MEETING #2 NOTES

- This is the second in a series of four Advisory Committee meetings for the SR 125/SR 32 Focus Area.
- This meeting is intended to be a working meeting. It will focus on reviewing the results of the preliminary studies completed for each concept discussed at the first Advisory Committee meeting; discussing possible refinements to be made to the concepts; and determining whether or not to advance each concept for further study.

Eastern Corridor Segments II and III SR 125/SR 32 Focus Area

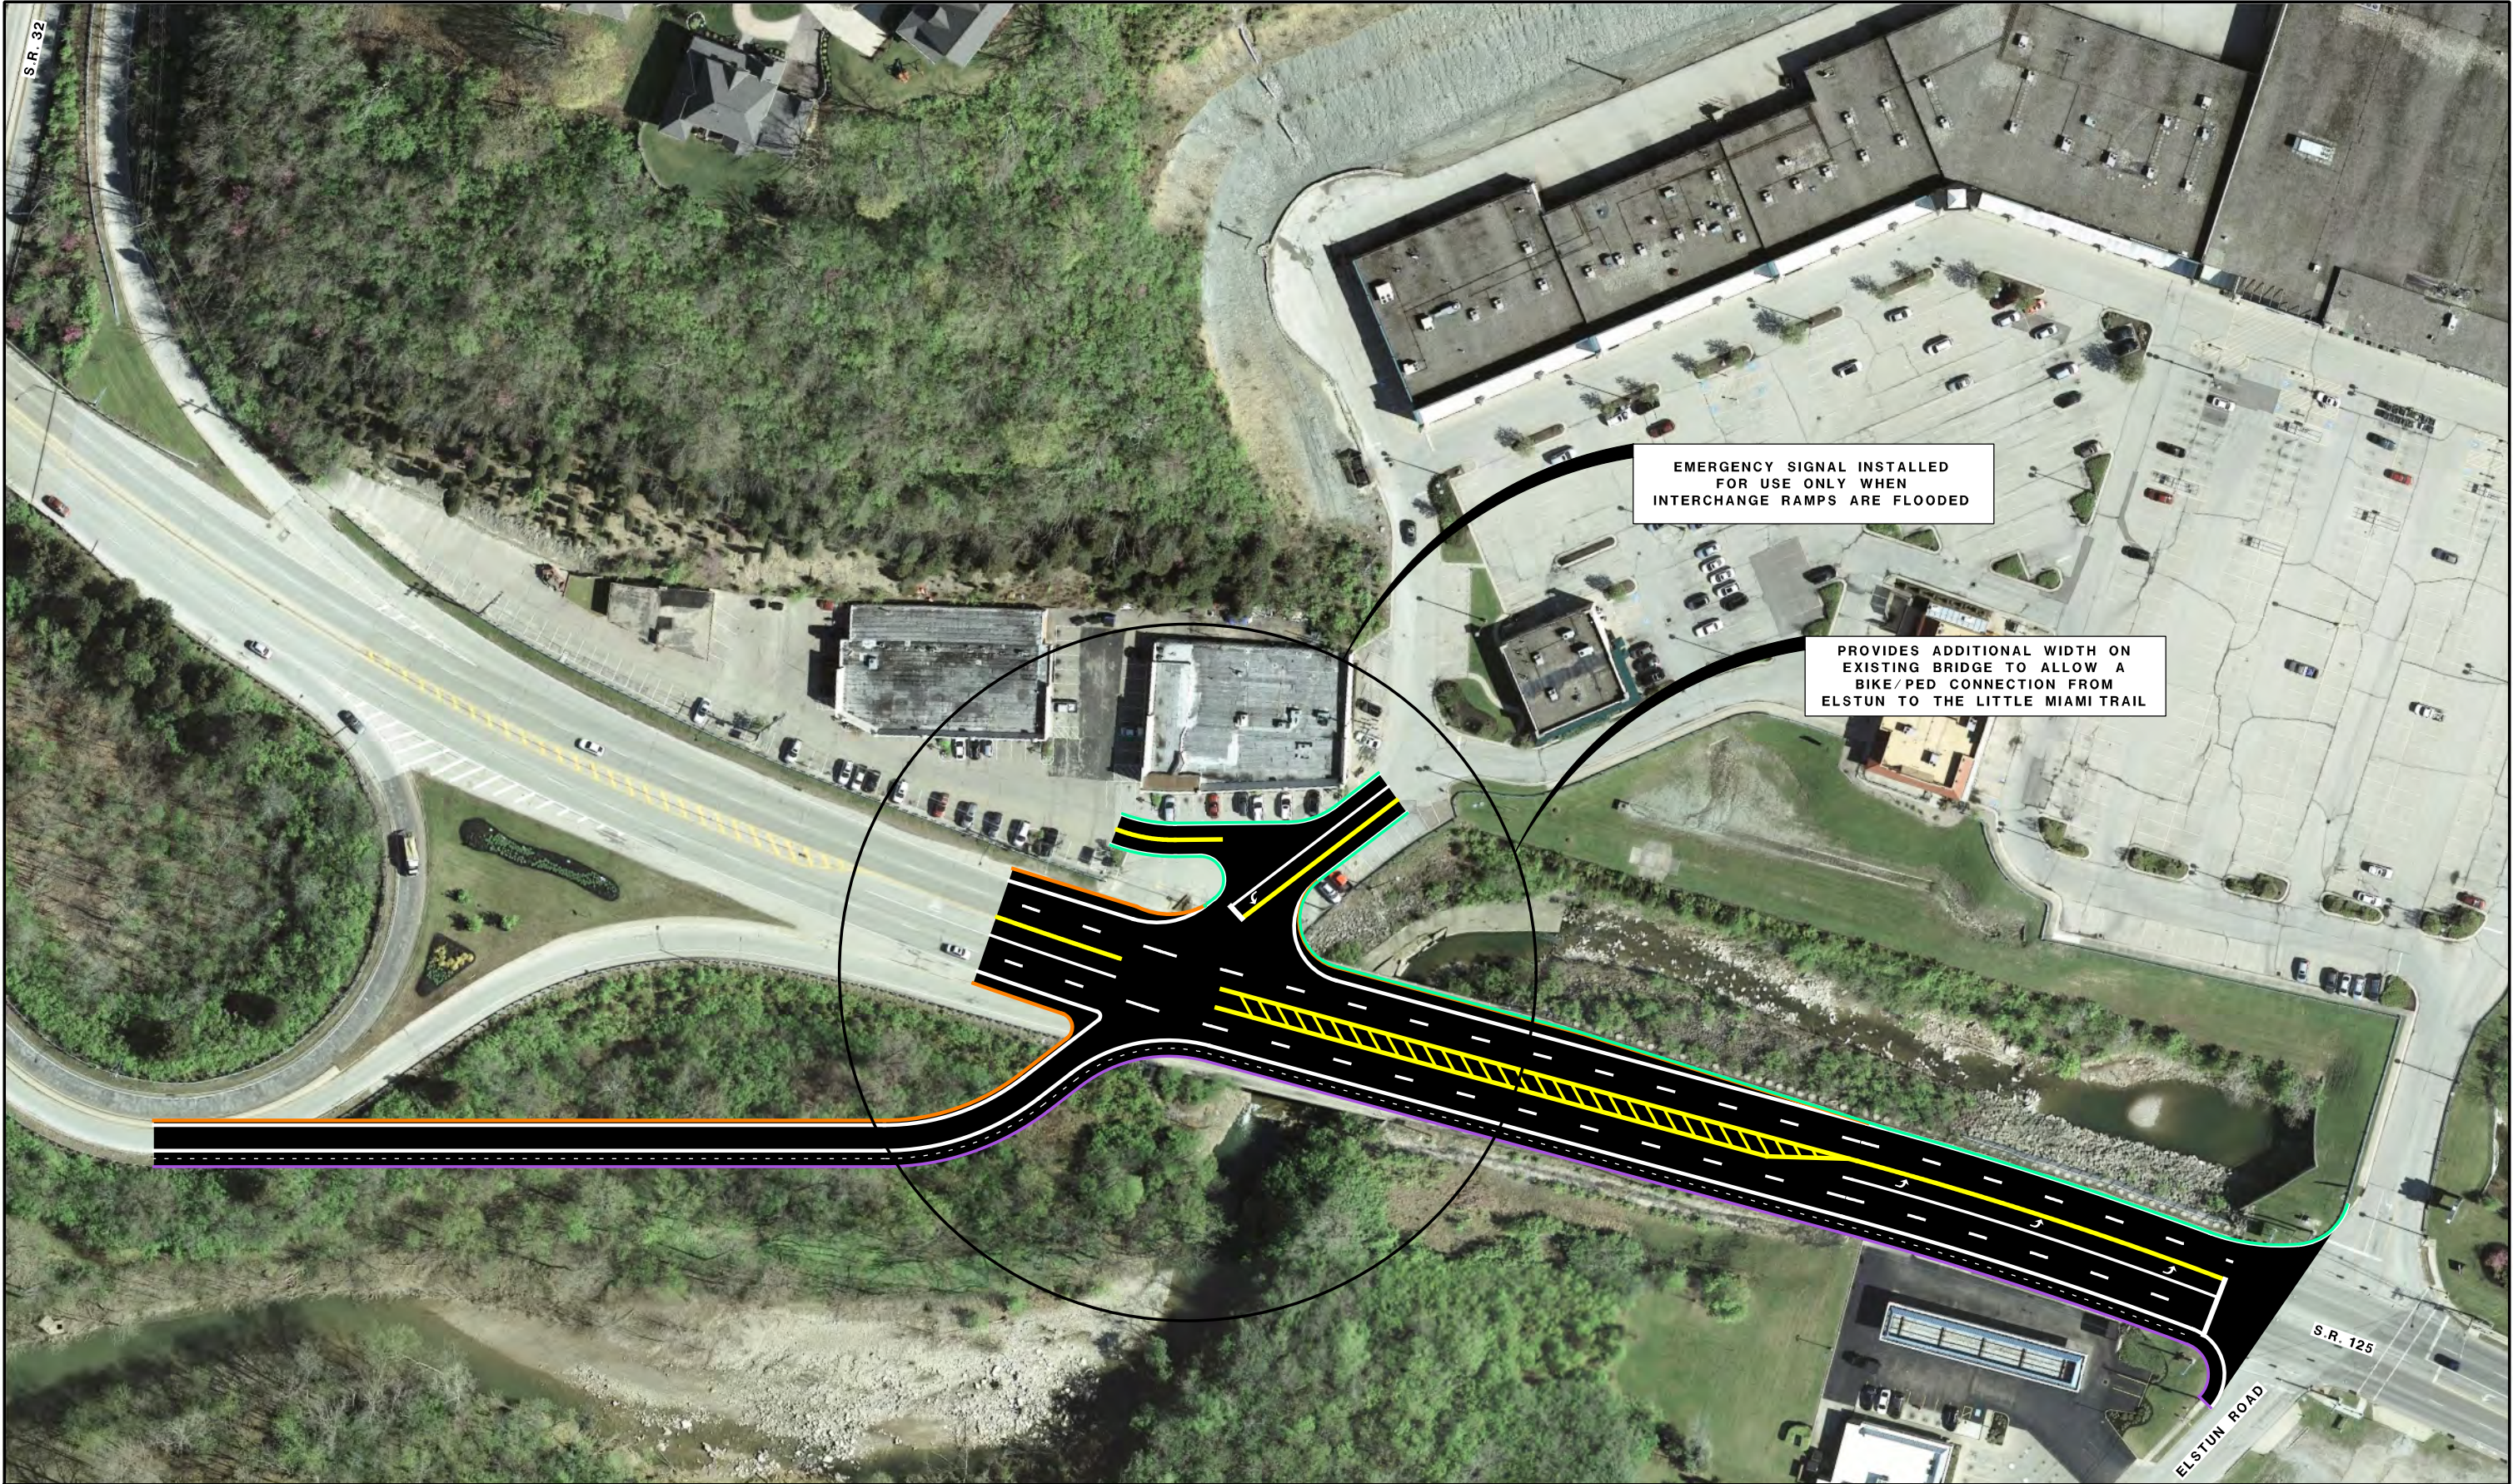
- In addition to providing bike/pedestrian access on the south side of SR 125, this concept would include placing an emergency traffic signal on SR 125 near the entrance of the strip mall.
 - Signal would allow vehicles to make a protected U-turn and access SR 32 from westbound SR 125.
 - The new signal would function as an emergency signal only when underpass ramps are flooded.
- This concept modifies the ramp configuration to more traditional intersection.
- Concept X-1g appears to work better.

- No further study because Concept X-1g appears to function better.

Figure X-1G and 125-4
MODIFY RAMP CONNECTION FROM S.R. 32 TO S.R. 125
TO ROUNDABOUT

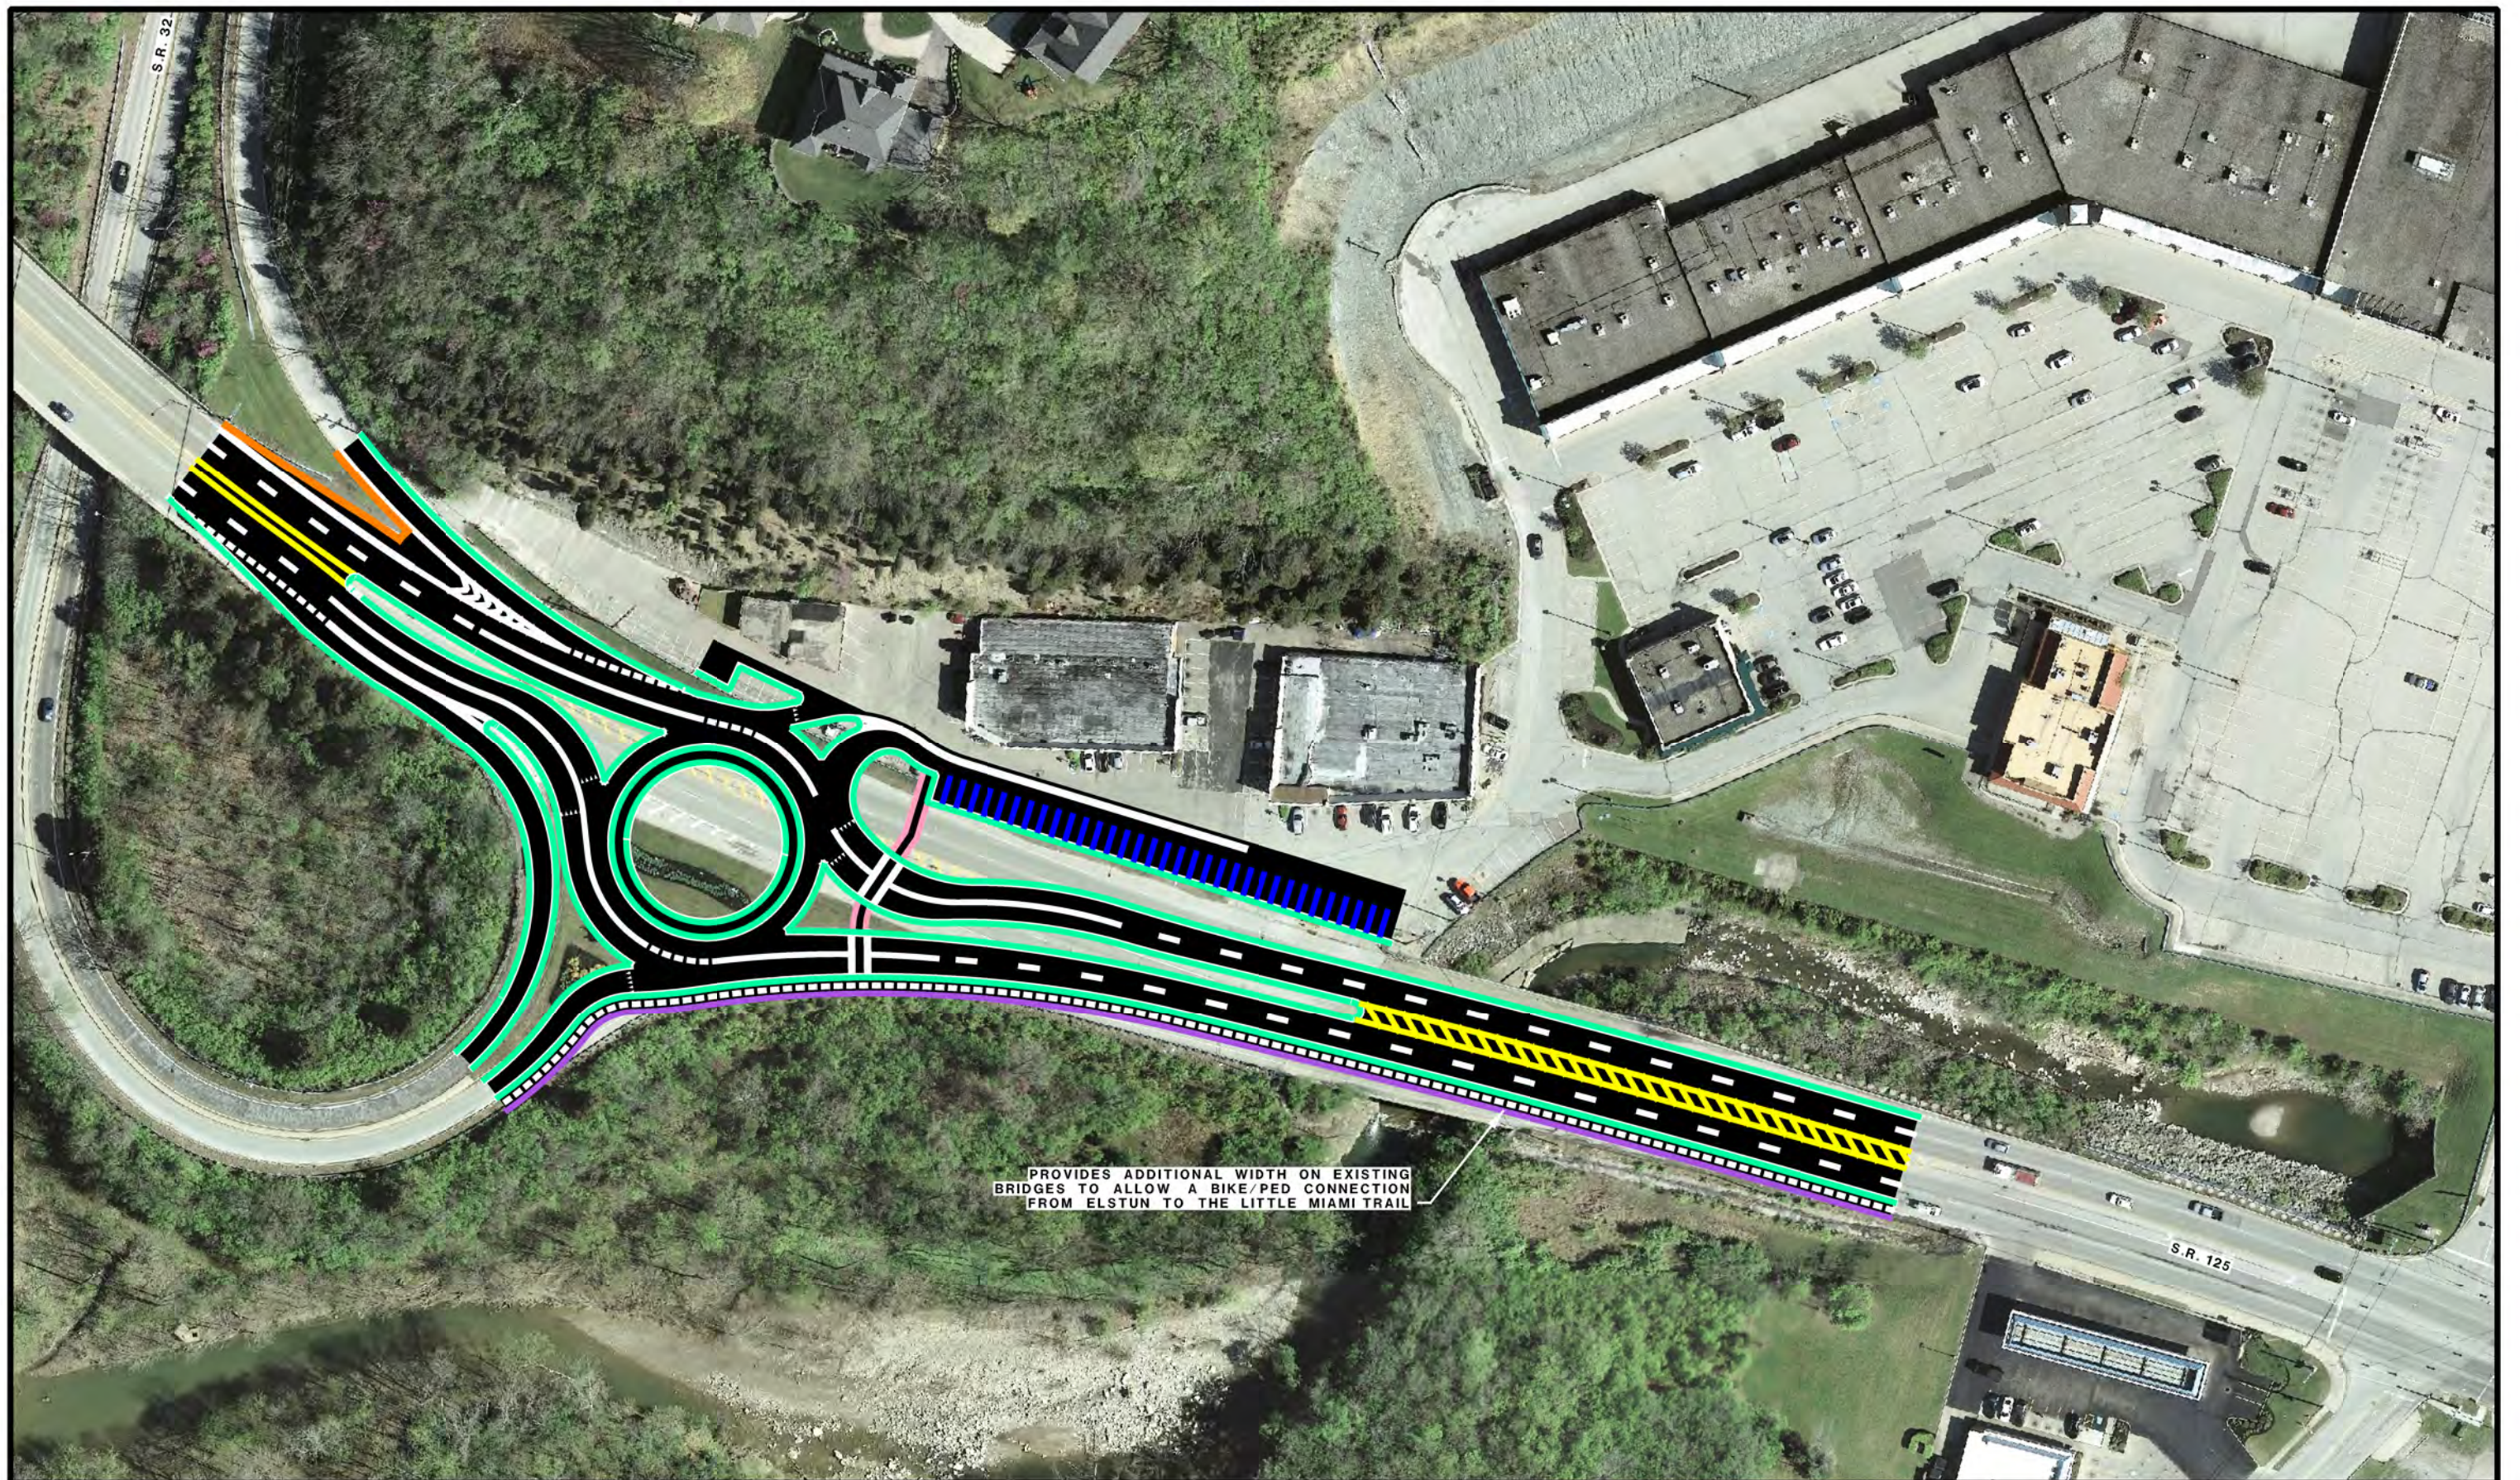
- Concept provides space on bridge over Clough Creek for bike/pedestrian connection.
- Facilitates access to SR 125/Clough during flooding events.
- Roundabouts slow vehicles down but allow for continuous movement.
- Initial analysis indicates concept would provide a Level of Service (LOS) D during morning peak hours and LOS C during evening peak hours.
- Skytop Pavilion is being redeveloped into approximately 230 apartments. The buildings containing businesses to the immediate west of Skytop will remain.

- Concept provides space for a bike path along the south side of SR 125.

- Advance for further study.
- Consultant to consider moving parking lot access along the north side of the roundabout to an alternate location.
- Consultant to look at adding turn lanes to facilitate access to and from Skytop Pavilion.

- Advance with X1-g.
